R. M. Cole, Kingston Fossil Plant

KINGSTON FOSSIL PLANT (KIF) - INSPECTION OF THE ASH DISPOSAL AREAS

KINGSTON FOSSIL PLANT- ANNUAL FOSSIL ENGINEERING INSPECTION OF ASH
DISPOSAL AREAS

ASH POND DIKE
PLAN-RAISING ASH DISPOSAL
AREA DIKE

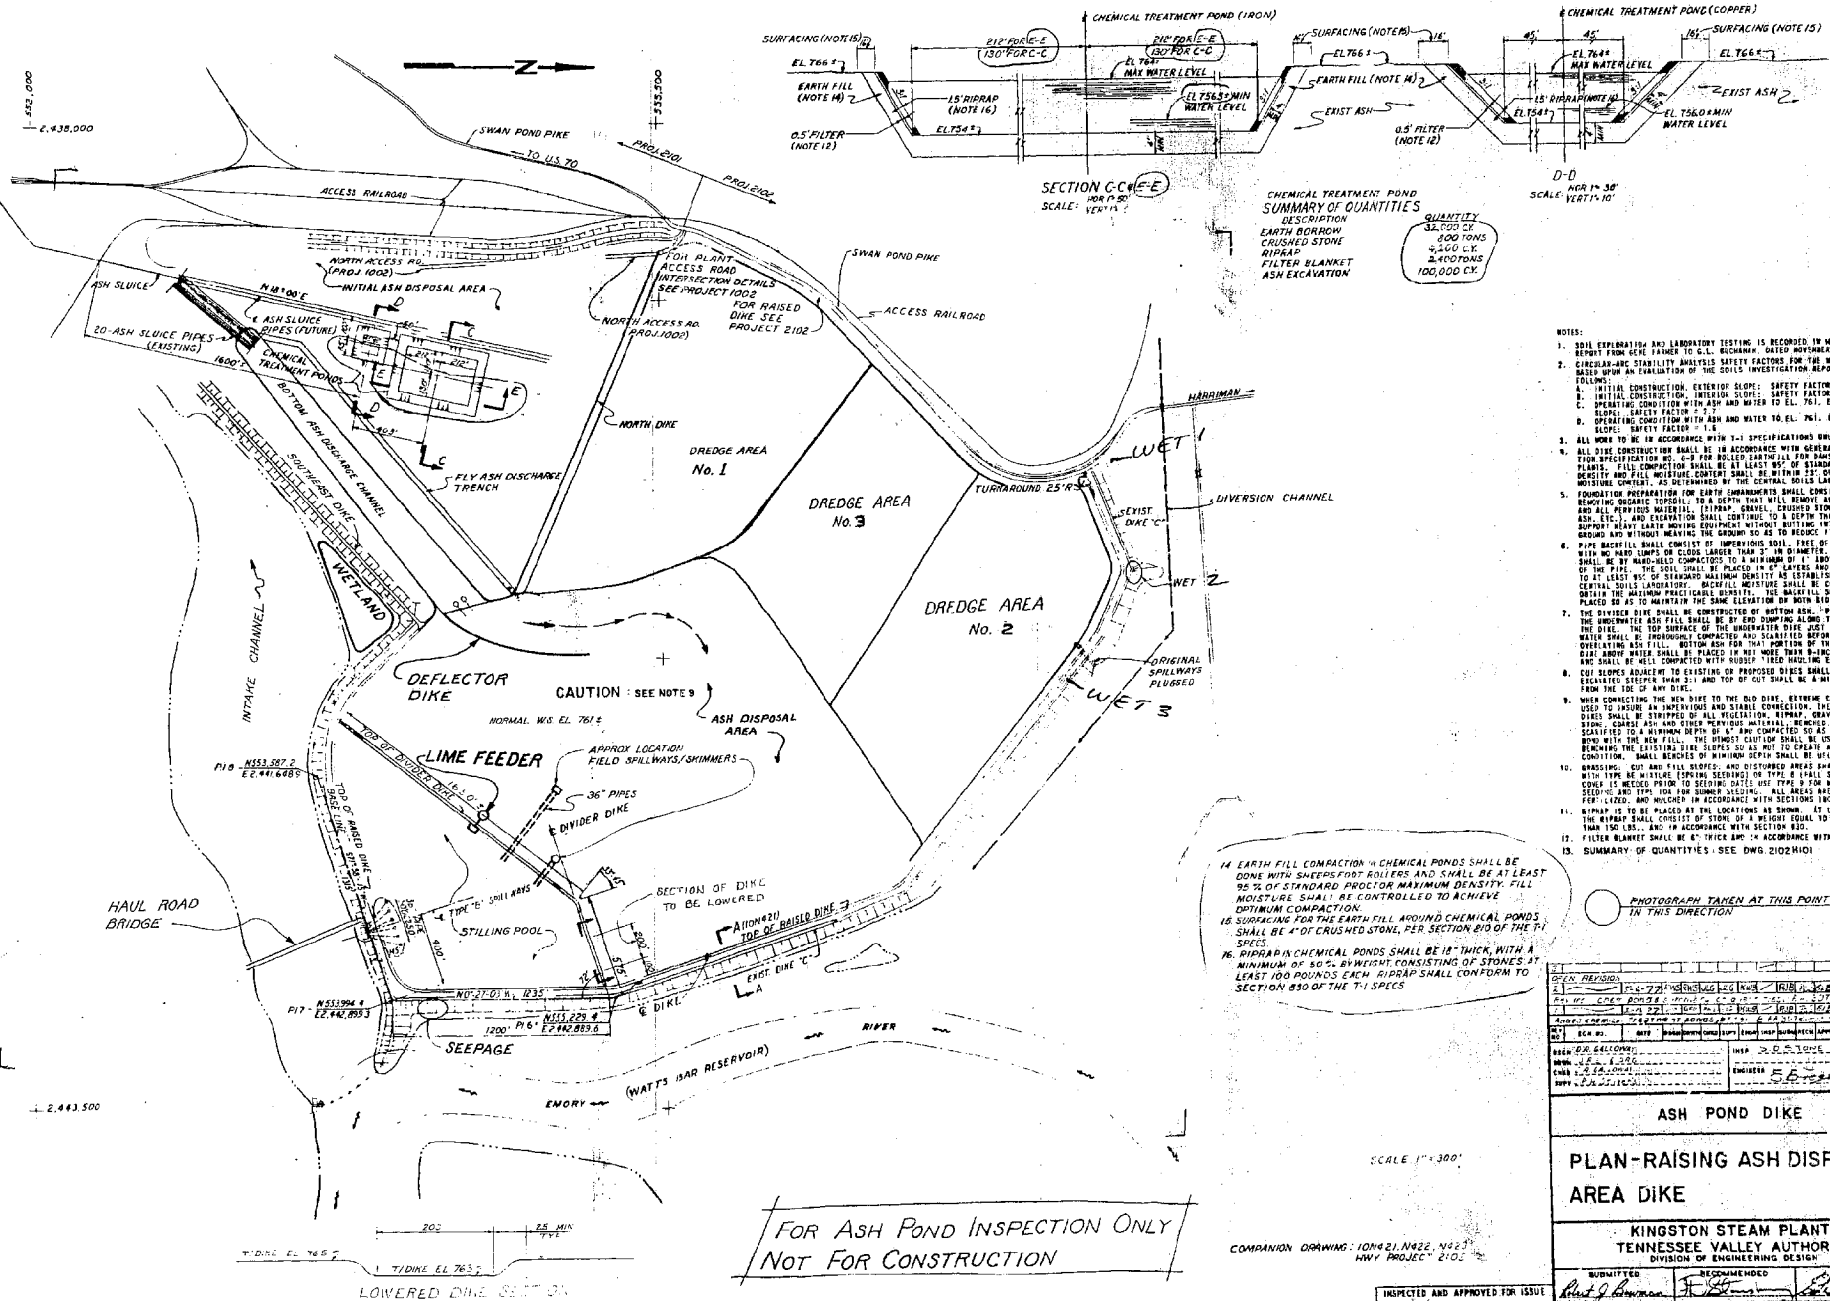
2.1 Dike "C" appears to be stable although there are three wet surface areas and one area of the slope sluffing (see 2.1.6).

2.1.6 There is a sluff about 150 feet from Swan Pond Road on the outside of dike "C". This 50 foot sluff has been checked three additional times

This appears to be a surface sluff caused by a temporary condition of water collecting and crossing the road from an area being prepared for closure and is not a structural problem.

- 2.1.7 Runoff water from the new runoff pipes are washing out dike "C" and forming gullies along it (see 6.3).
- 2.2 Seepage of redwater persists along the exterior slope of the southeast dike. The redwater is collected in an interception ditch and routed to an engineered wetland. The water is then pumped to the ash pond. Cattail and other aquatic growth continues to increase in the wetland and removal and replacement will not be necessary for several years.
- 2.3 Red water seeps along Dike C were observed during the 1993 inspection, but could not be observed during this inspection because the lake was at summer pool.

This is an old area of seepage and past reports indicate that it does not appear to be increasing.
- 2.4 The divider dike at the stilling pool appears to be stable.
- 2.5 The original north dike drainage (now south toe of cell 1) has been lowered to remove the ponding. The road crossing at the east end of the ditch was reworked and the pipe lowered four feet. An additional section of pipe was also added. This allows an extra four foot drop in the 1800-foot ditch.

- 6.1 The algae needs to be removed from the skimmer of the western most spillway on a continuous basis.
- 6.2 Additional drain pipes (at least 2) should be added to Dike C across the berms.
- 6.3 Add fill, tamp, and use riprap at each pipe along Dike C.
- 6.4 Plant personnel should replace the rubber liner in the ash sluice ditch or continue to clean out the ditch and fill with earth liner.
- 6.5 Continue to add and monitor riprap at the outlet end of the existing dike storm drains and on the inside slope of the stilling pool dike to prevent additional erosion.
